SIERRA CLUB  
CALIFORNIA

316(b)  
Once Through Cooling  
Deadline: 8/15/06 5pm

**Subject: Proposed Statewide Policy for Once-Through Cooling**

Figure 1

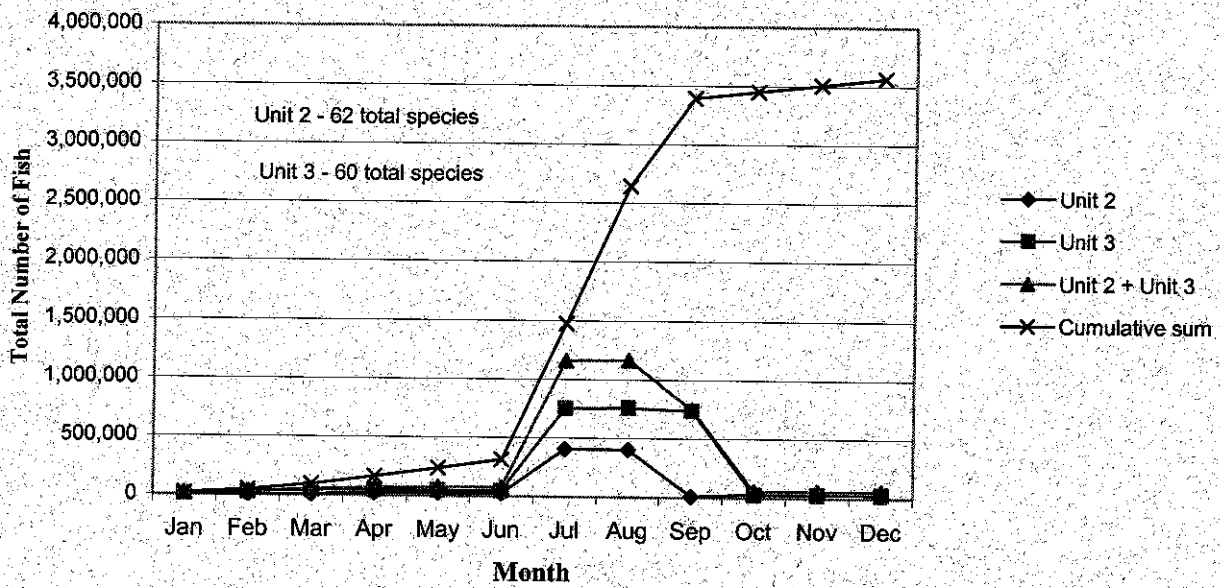
In fact we have data that shows a strong seasonal effect on impingement. This data<sup>1</sup> was obtained from the San Diego Regional Water Quality Control Board during the San Onofre Nuclear Generation Station (SONGS) Units 2 and 3 NPDES<sup>2</sup> permit hearing. Attachment 1 Figures 1 and 2 are taken from the San Diego Bay Council comment letter for this hearing<sup>3</sup>. Figure 1 shows the number of fish species and number fish of impinged in 2003 for both Units 2 and 3. Figure 2 shows the weight of the impinged fish. The data reveals a strong seasonal influence, with highest fish losses in the summer months. It also shows that Unit 3 takes a much larger toll on the fishes than Unit 2; the 2.58 times more in the number of fishes and 2.88 times more in weight of the fishes. We have no explanation for this. The combined fish counts and weights are shown as the cumulative sums. The estimated total count of fishes impinged is 3,564,433. The estimated total weight of the impinged fish is 21,923 kilograms (48,231 pounds). SONGS are base load power plants so the flows would be constant.

We therefore, recommend that calculations to obtain estimates of impingement mortality entrainment from the actual flow rates must factor in the seasonal I&E losses and flow rate time series characteristics.
